THE MULBERRY HOUSE SCHOOL, SHOOT UP HILL, LONDON NW2 3XL

B: PROPOSED AMENDMENTS TO PLANNING PERMISSION NO. 2015/5184/P

Amended Report to the Planning Officer: JOHN DIVER

26 September 2016 (following the original report of 20 May 2016 to the previous Planning Officer)

Proposed Elevation C – Raised level of the underside of the top chord of the steel truss behind the glazing providing more daylight (MUL-A(0)C33)

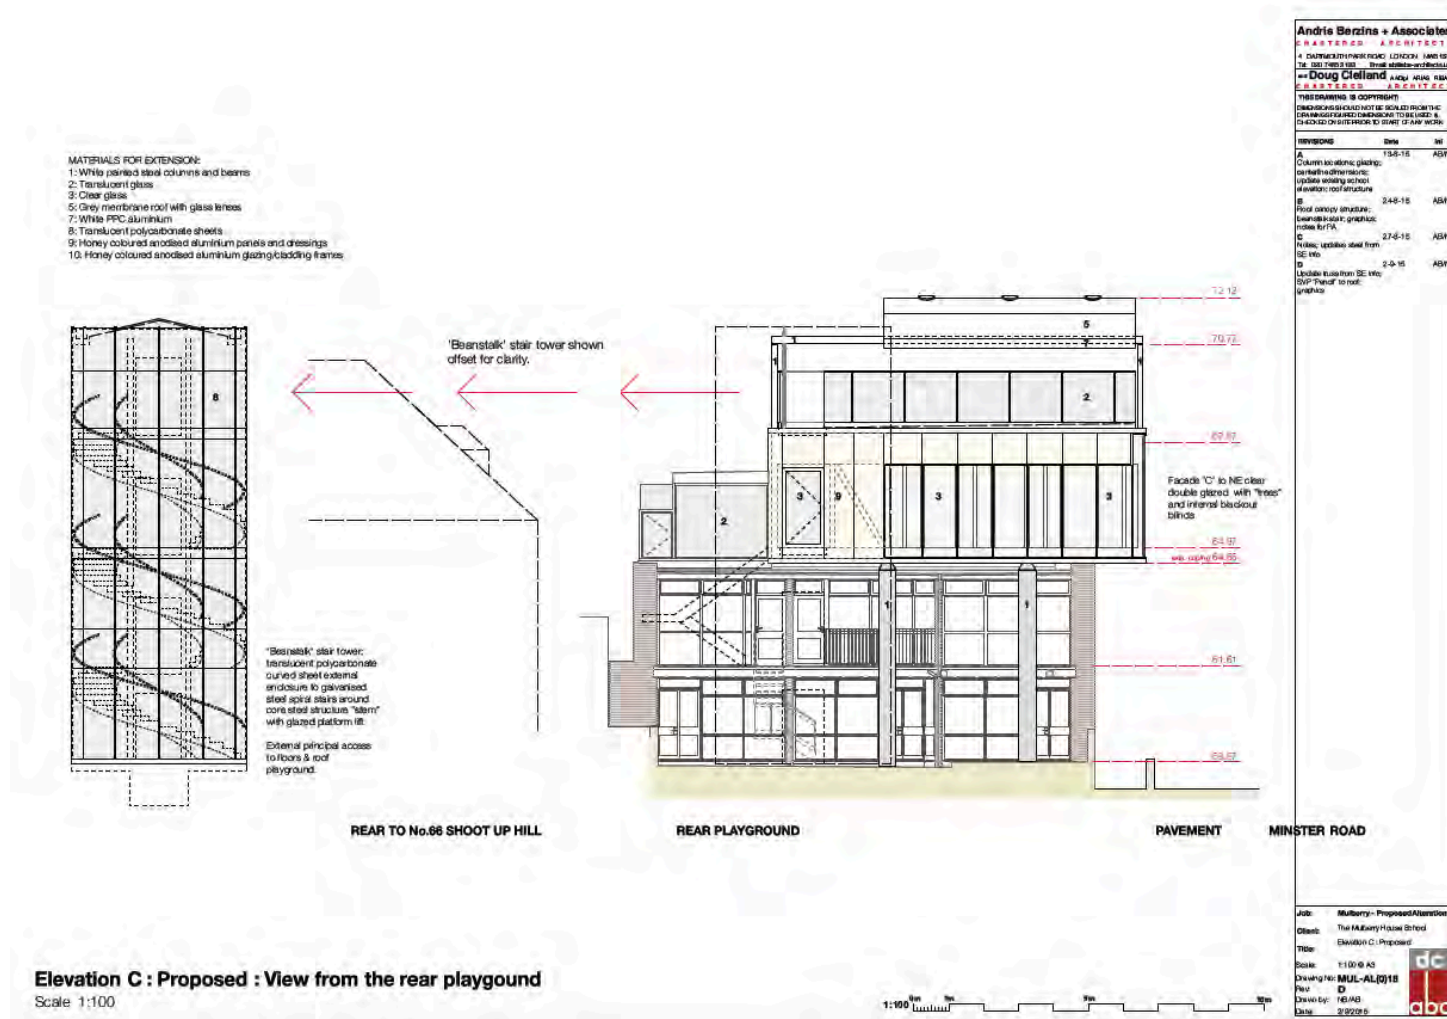
1 Alteration to Elevation C

Due to necessary changes in the structural design of the steel truss (that lies behind the glass façade) there will be a reduction in the truss's height to Level 68.00 (glazing now more consistent).

Revised holes in the 'Cloud' roof: due south bringing sunlight onto the play area at midday on 1 June – International Children's Day (MUL-A(0)C20)

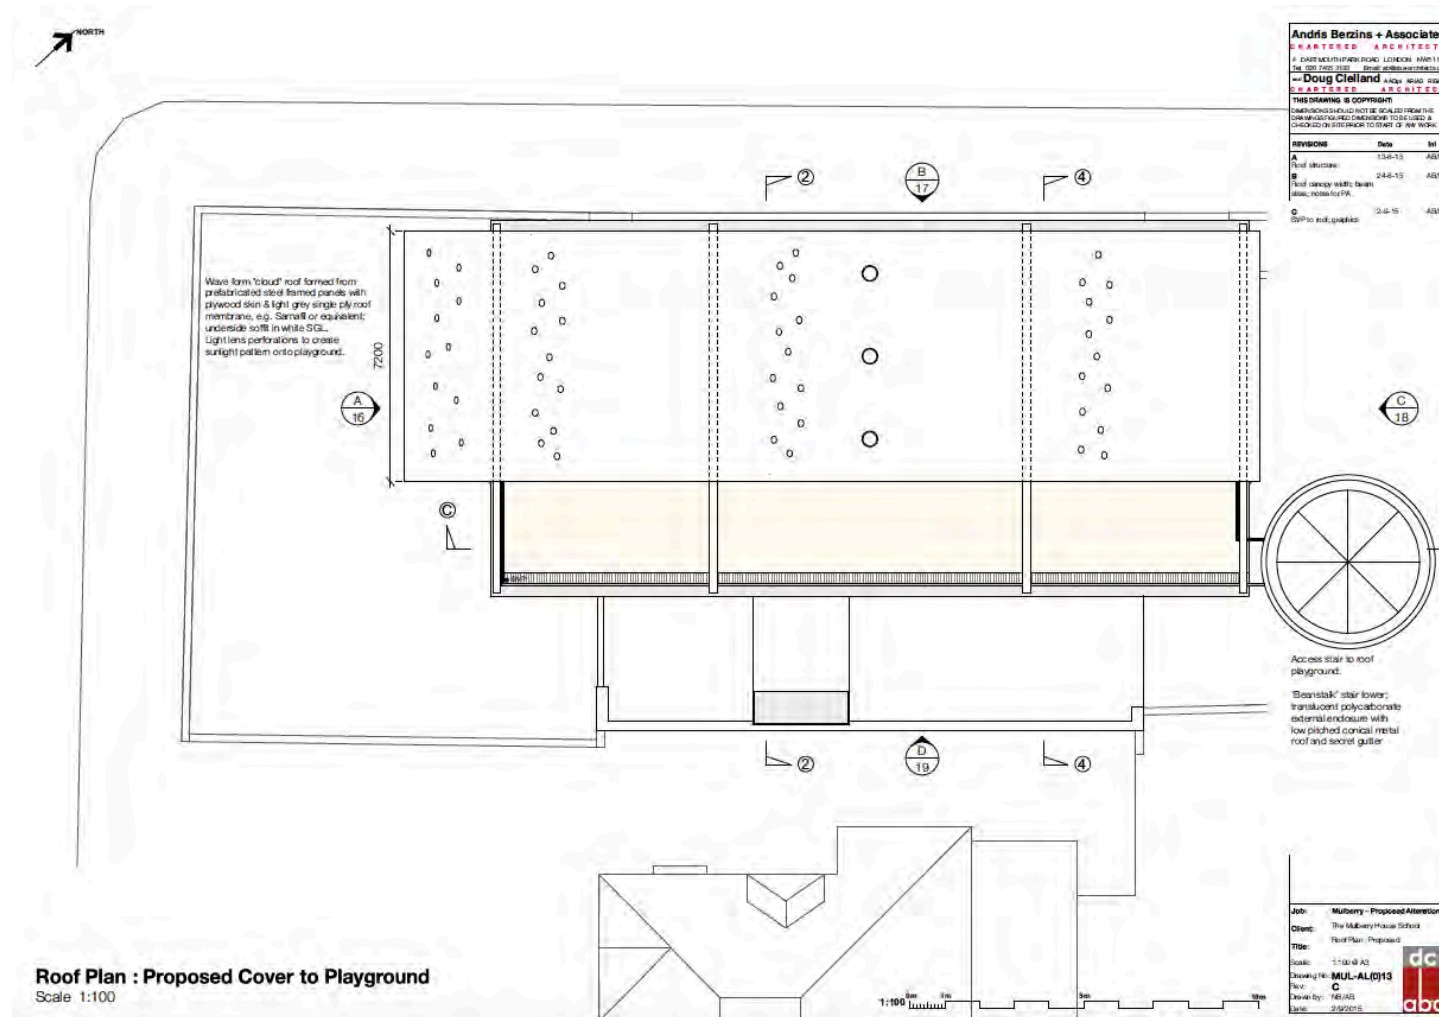
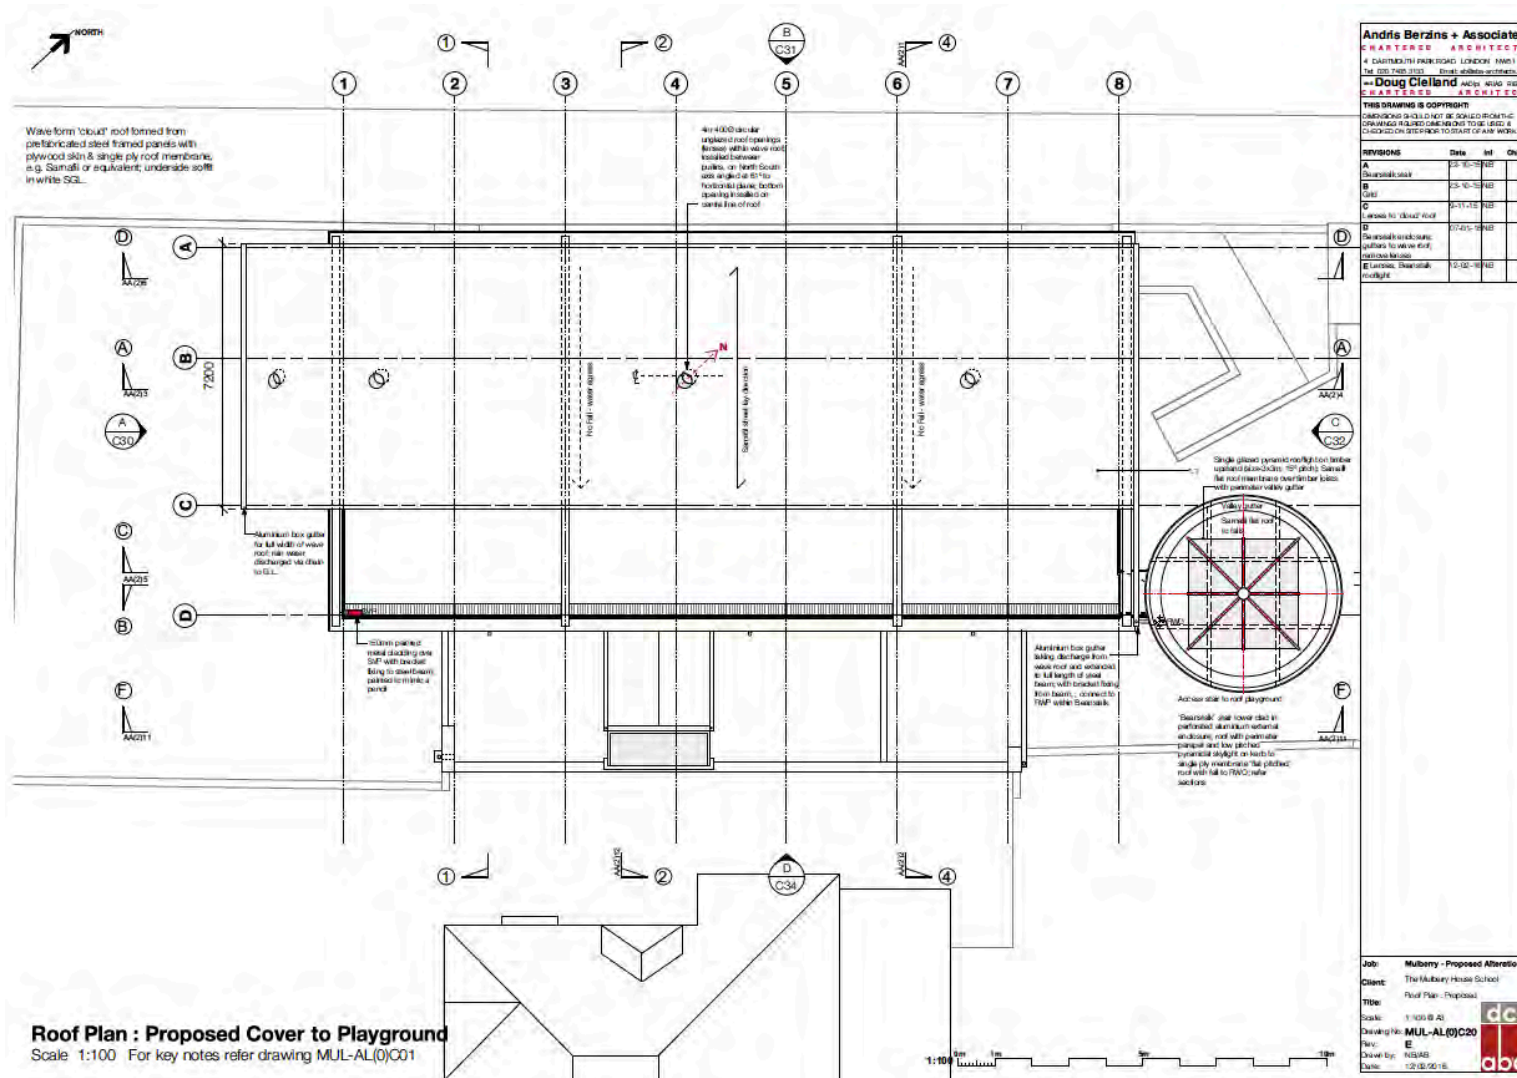
2 Revised holes in the 'Cloud' roof

The number of 'lenses' has been reduced to 4 in order to intensify their significance. Their geometrical angles will allow direct sun to come straight down from due south onto the play area at midday on 1 June – International Children's Day.

Approved plan showing two small areas of green roof on existing building (MUL-AL(0)11 REV D)

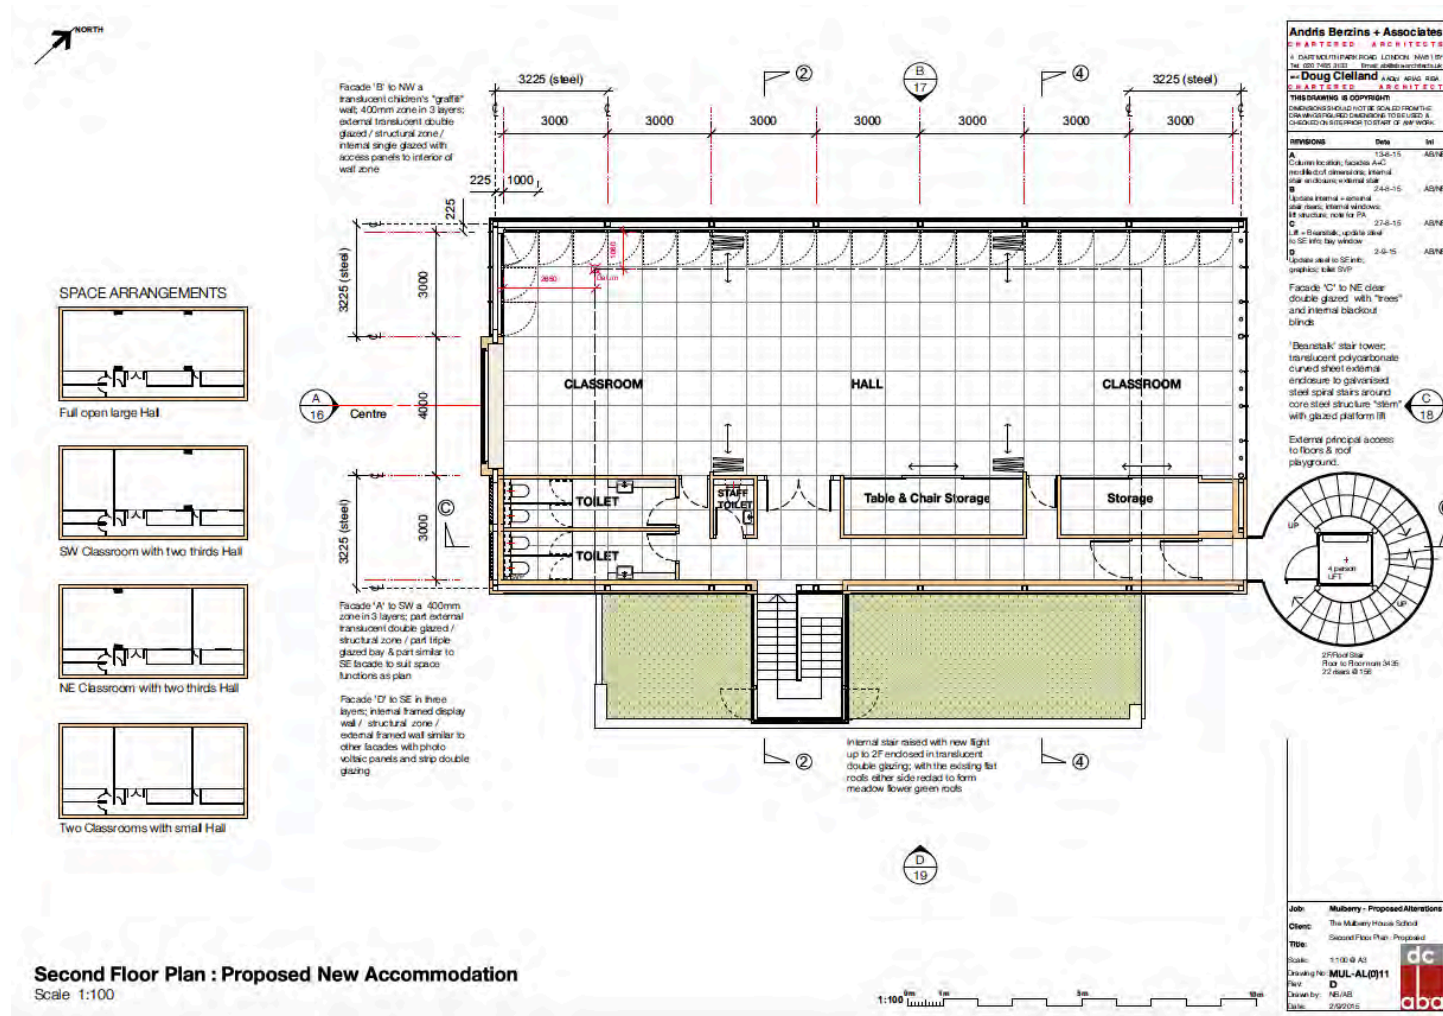
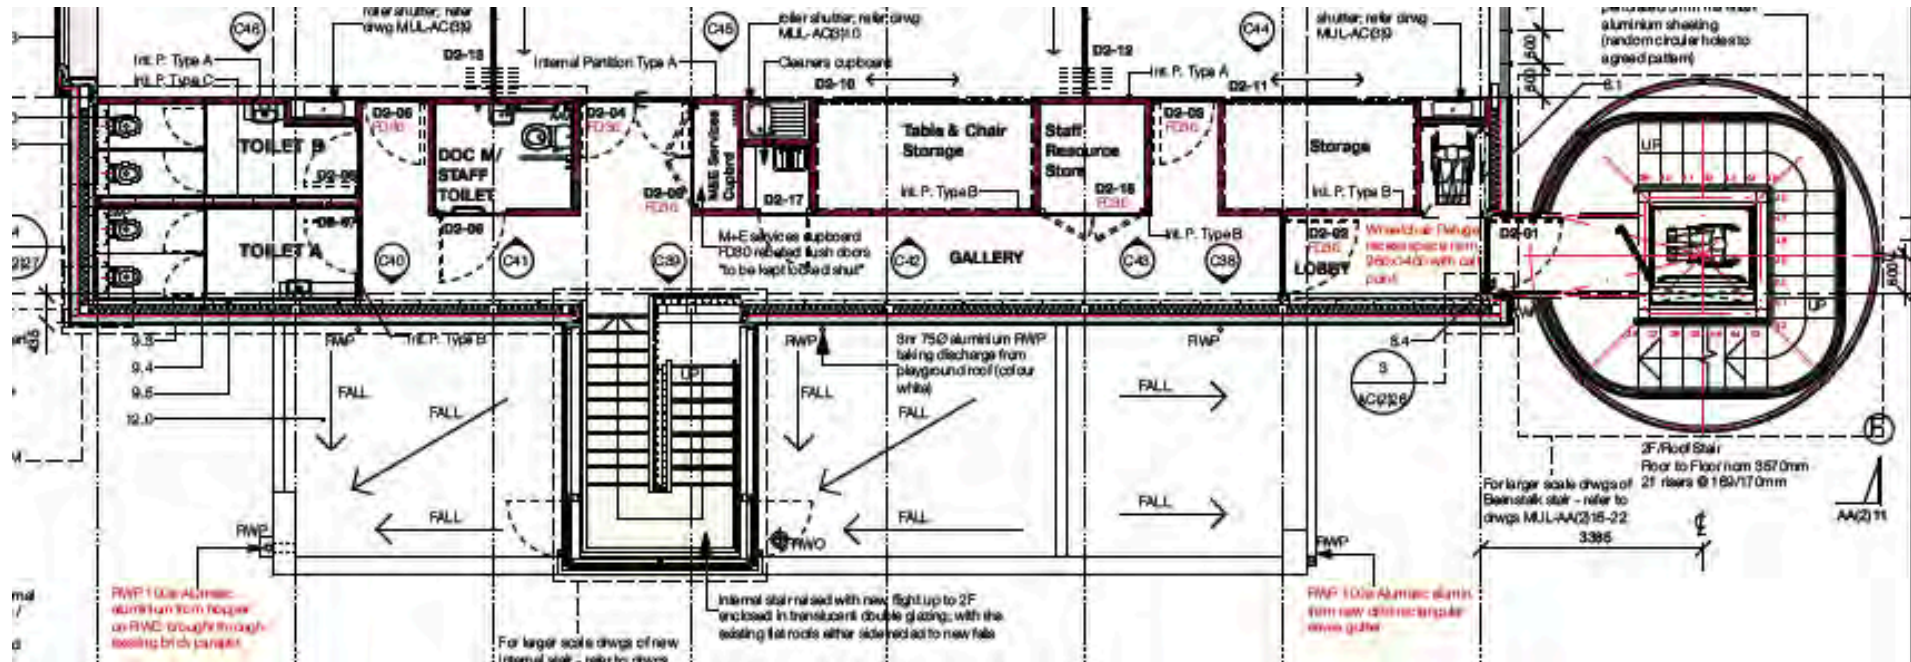
5 Removal of small areas of green roof on existing building due to structural limitations

Due to the limited structural carrying capacity of the existing roof of the school, the proposed extension building spans across the existing superimposing zero stresses on the existing walls. This limitation also affects the original intention to have two small areas of 'green roof', one on either side of the internal stair. As these small parts of the project will not be visible from inside the building or indeed significantly from the surrounding buildings, a single membrane roof will replace the existing felt roof and will not result in a significant loss.

Approved Elevation B with windows in translucent glazing – note existing alarm devices not shown but shown on next drawing (MUL-AL(0)17 REV D)

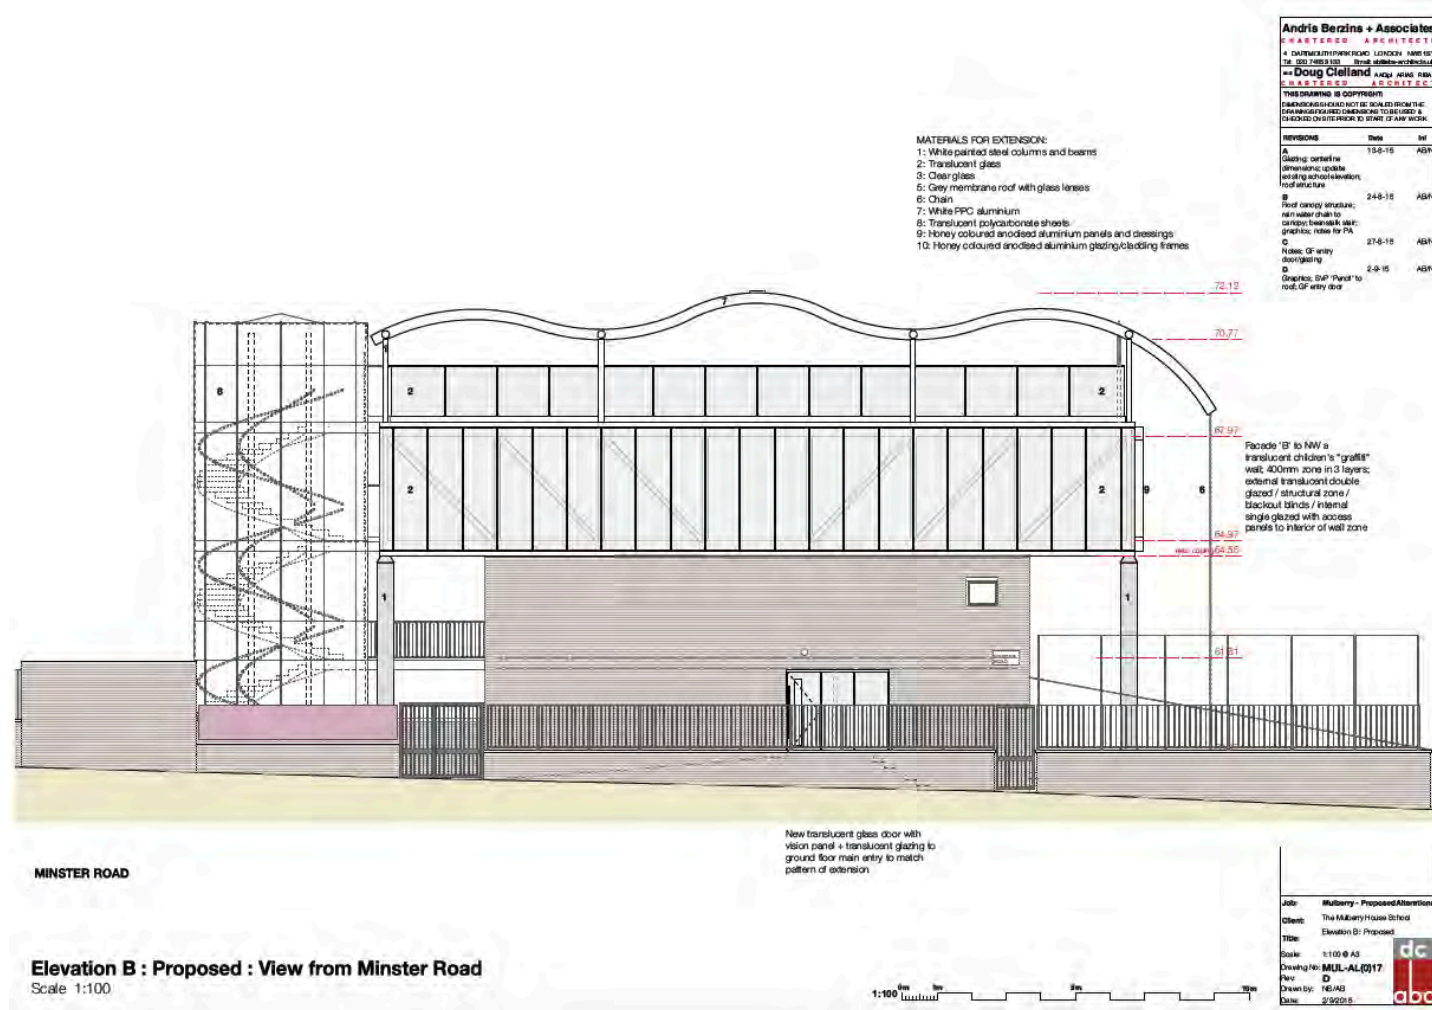
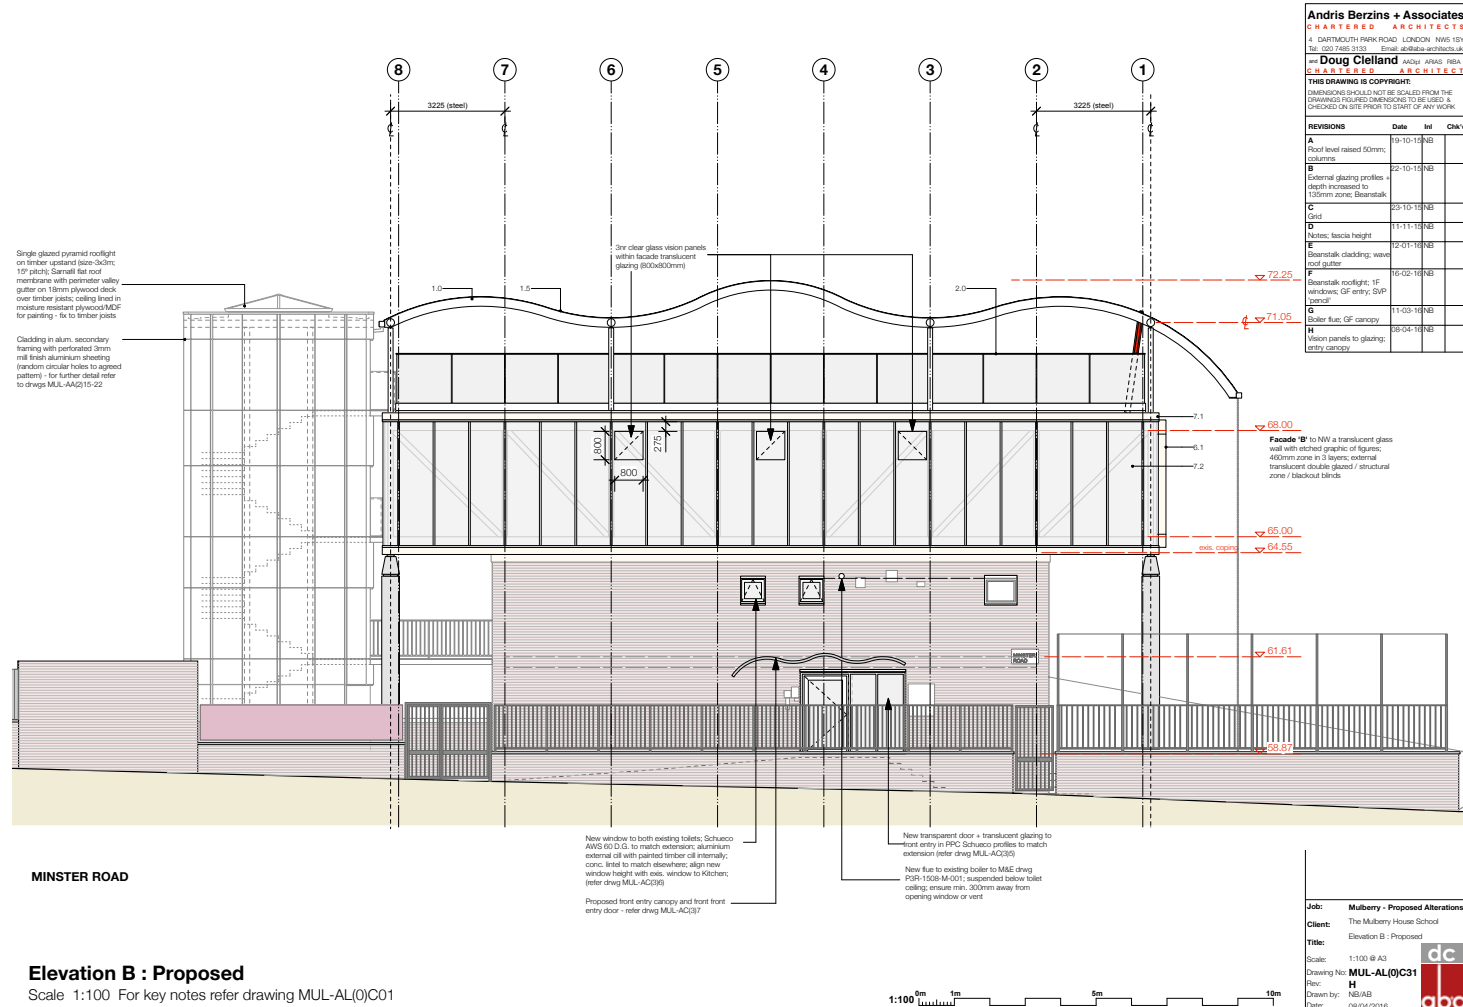
6 Two small windows added to existing building (Elevation B) to provide light and ventilation to toilets

Due to the removal of a rooflight to enable the construction of the extension, there are two toilets on the Minster Road side of the school that are now in darkness, requiring artificial light and therefore energy consumption at all times of the day. It is therefore proposed that two small windows are introduced into the existing wall, sized with the existing kitchen window in mind.
